Re: Huntington Beach Energy Project (12-AFC-02)
Applicant's Responses to Staff's Informal Requests (Visual Resources)

***APPLICATION FOR CERTIFICATION FOR THE
HUNTINGTON BEACH ENERGY PROJECT***

Docket No. 12-AFC-02

Staff's Verbal and Email Requests 1-3 (Visual Resources)

Figure 5.13-9R1
KOP 5 (Revised) - View Toward Project
from Huntington-By-The-Sea RV Park
 AES Huntington Beach Energy Project
 Huntington Beach, California

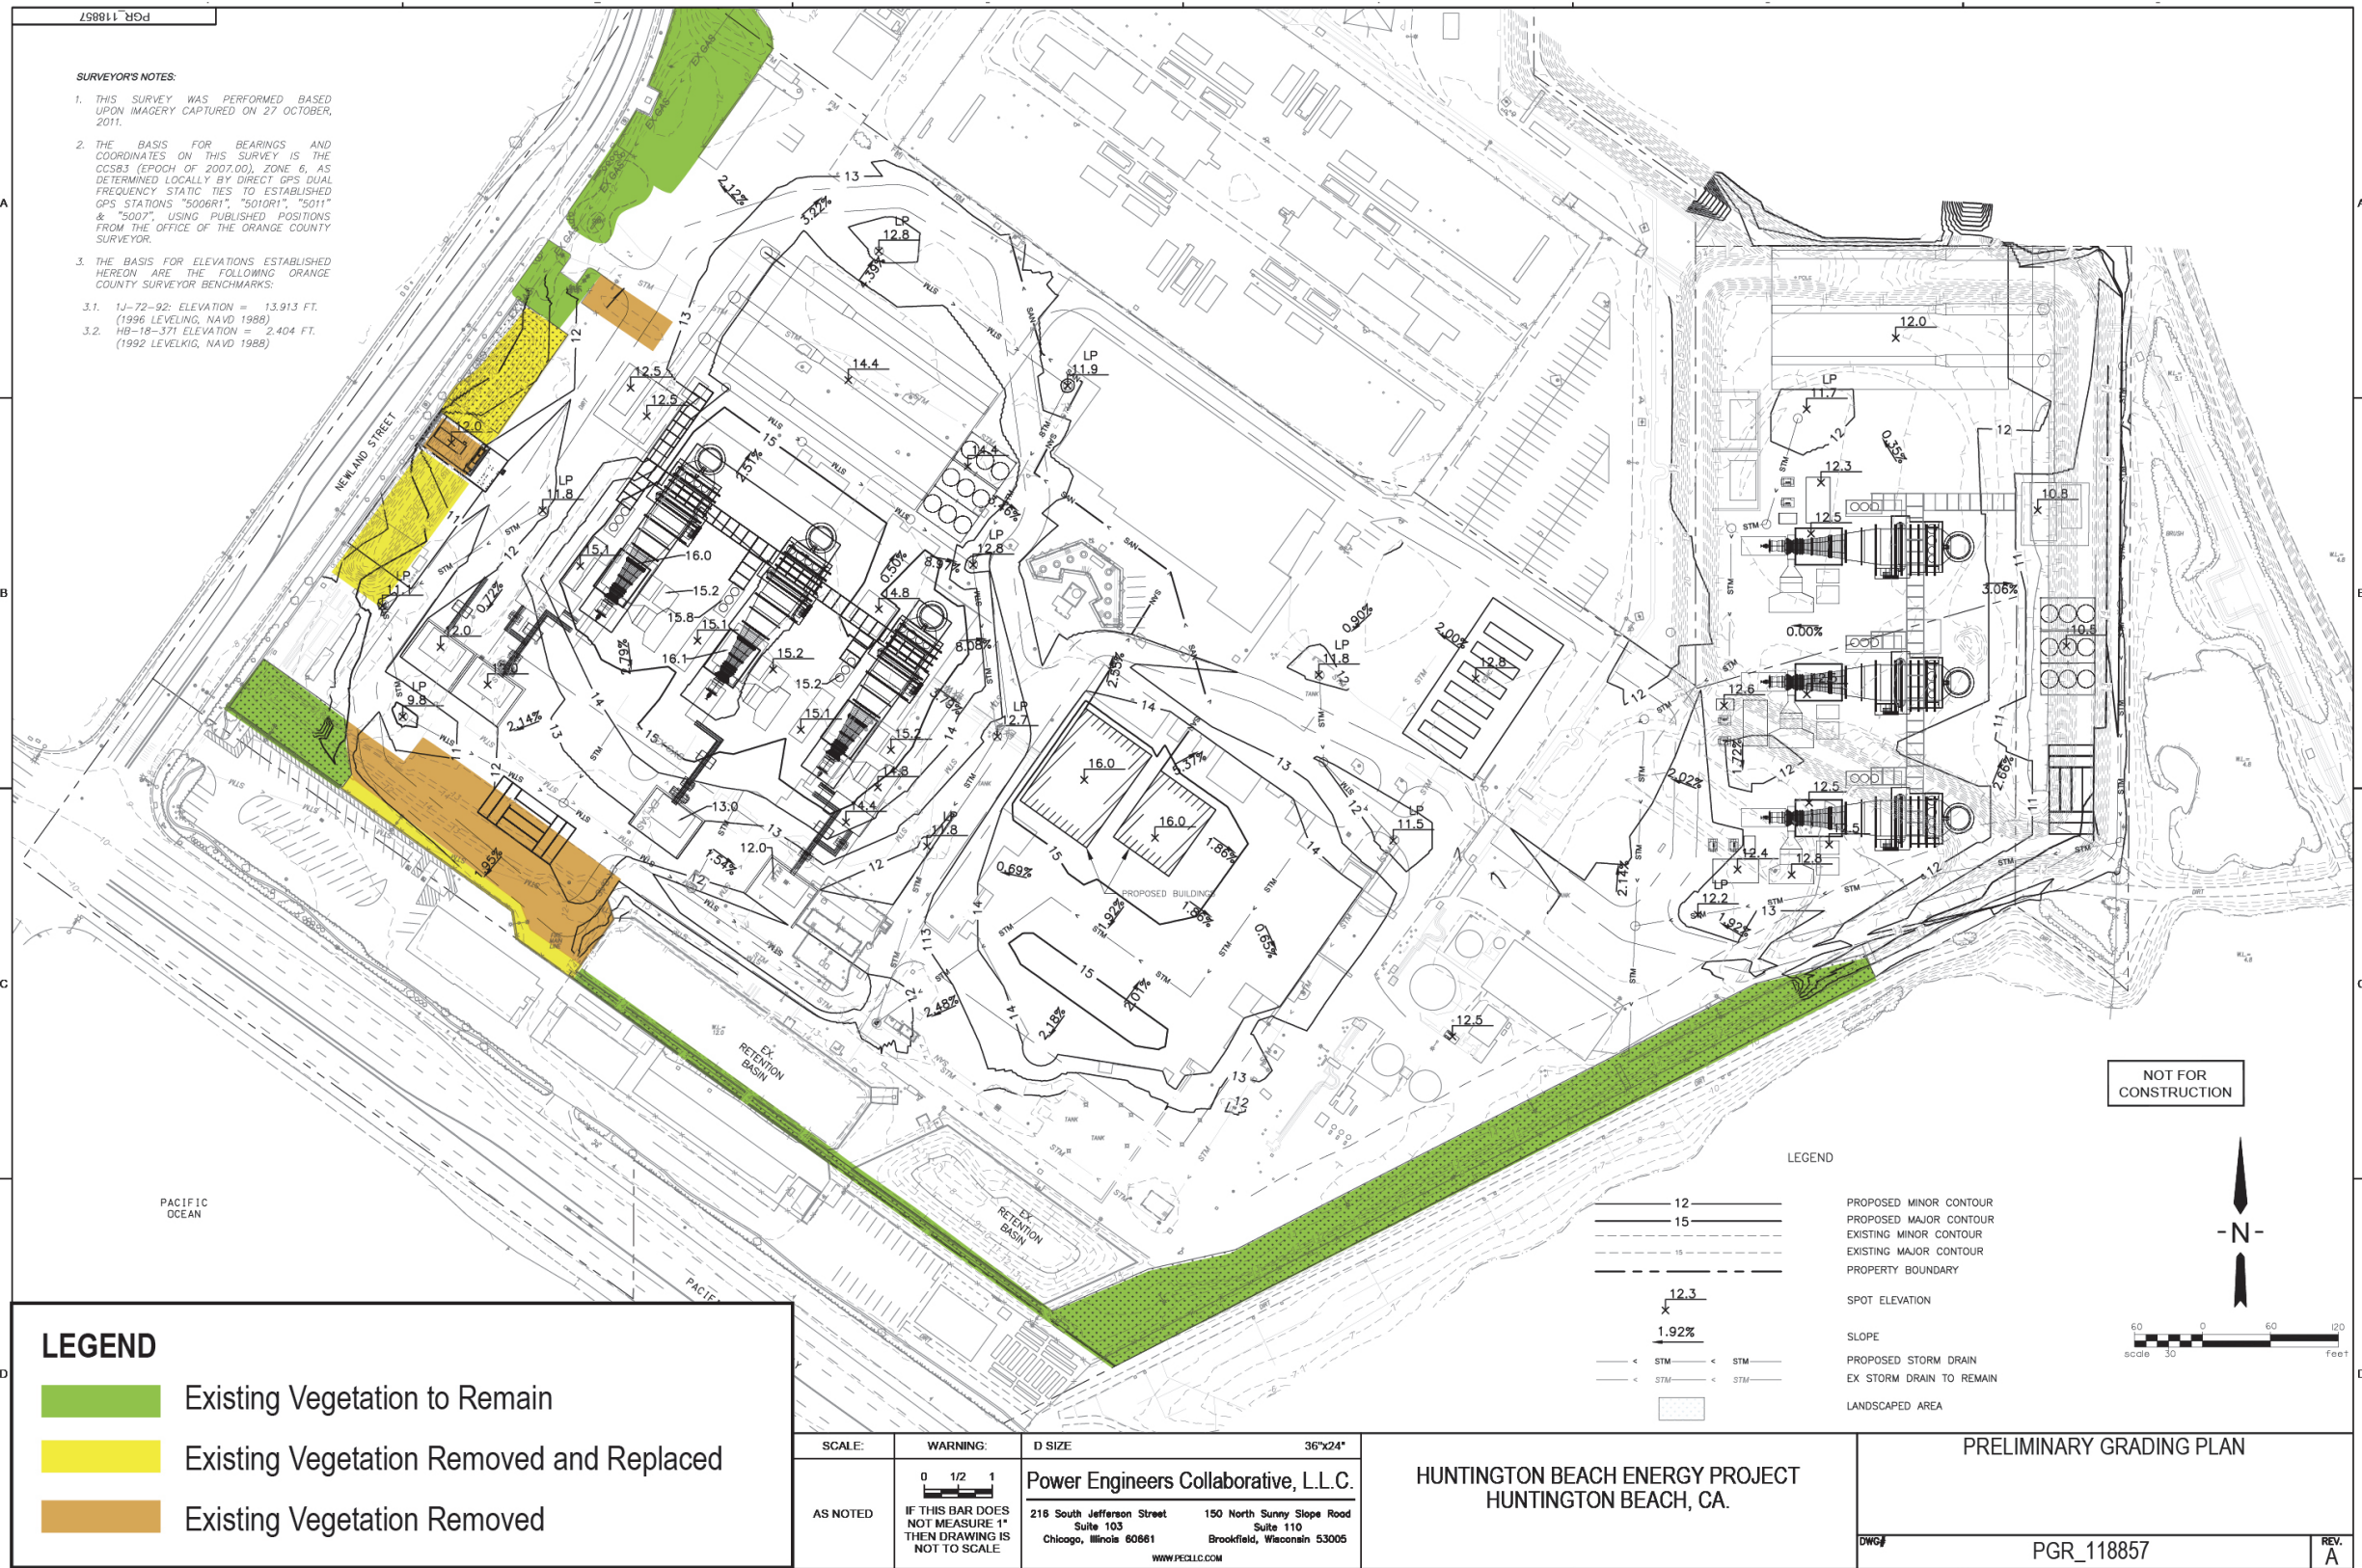
1. A verbal request (March 22, 2013, telephone call) from Felicia Miller to the Applicant's consultant representative (Robert Mason, CH2M HILL) stated that KOP 5 does not show the air-cooled condenser, and requested a revised KOP 5 to be provided.

2. An email request (April 22, 2013) from Felicia Miller to the Applicant's consultant representative (Robert Mason, CH2M HILL) requested revision of at least two of the visual simulations, including KOP 1 from Huntington State Beach and KOP 5 from the Huntington By-The-Sea RV and Mobile Home Park. Staff anticipates receiving a revised visual simulation for KOP 5 that shows 1) the previously requested complete field of view for that viewpoint, and 2) the effect of removing landscape plantings that would be evident from this viewpoint. Staff also indicated a revised visual simulation for KOP 4 from Magnolia Street would also be useful because it appears to staff that some of the lower HBEP structures could possibly be screened by existing vegetation that would be removed.

Response: As requested, Figure 5.13-9R1 (Revised) has been updated to include the air cooled condenser. The revised KOP 5 viewpoint was established slightly west of the original KOP 5 viewpoint, and inside the front gate of the Huntington-By-The-Sea recreational vehicle park, to permit a more widely encompassing view of the site to be documented. The Revised KOP 5 view uses two photo frames that were spliced together to create a panoramic view that encompasses a portion of the existing power plant facility as well as areas of the site where the HRSGs and air cooled condensers for HBEP Block 2 will be located.

Response: Attached are revised Figures 5.13-5R1, 5.13-8R1, and 5.13-9R1 that present the three revised visual simulations requested for KOPs 1, 4, and 5. These simulations represent the existing views toward the Project and as the Project would appear with five years of landscape growth. These simulations reflect the implementation of landscaping that is planned to replace existing landscaping that must be removed during HBEP construction and to enhance the existing landscaping. The landscaping has been designed with the objective of providing screening of lower project elements and creating a perimeter for the site that has a visually attractive relationship with its surroundings. The landscape scheme includes extension of the existing perimeter wall around the site's west, south, and east sides, and planting of large-size palm trees to create immediate visual effects.

Figure 5.13-5R1 includes a photo of the existing view toward the project site from KOP 1 - Huntington Beach State Park and a simulation of the same view as it would appear 5 years after development (including installation of the landscaping). Figure 5.13-8R1 presents the existing and the simulated 5 years after development (including installation of the landscaping) views from KOP 4 - Magnolia Street. Figure 5.13-9R1 presents a view from a revised KOP 5 - Huntington-By-The-Sea recreational vehicle park (including installation of the landscaping). In response to staff's verbal request received on March 22, 2013, the new KOP 5 viewpoint was established slightly west of the original KOP 5 viewpoint, and inside the front gate of the Huntington-By-The-Sea recreational vehicle park, to permit a more widely encompassing view of the site to be documented. The revised KOP 5 view uses two photo frames that were spliced together to create a panoramic view that encompasses a portion of the existing power plant facility as well as areas of the site where the HRSGs and air-cooled condensers for HBEP Block 2 will be located.
